Rezoning Transportation Analysis

Petition Number: 2021-079

General Location Identifier: 15705136

Transportation Summary

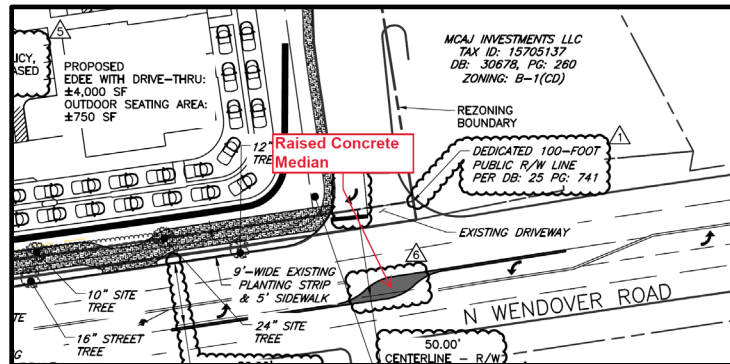
1. ~~**Curblines:** The proposed zoning district has a setback measured from back of the existing or proposed future curblines.~~
 - a. ~~**North Wendover Road:** The future location of curb and gutter is in its existing location.~~

~~Label and dimension the curb and gutter from the centerline for each road on the site plan.~~
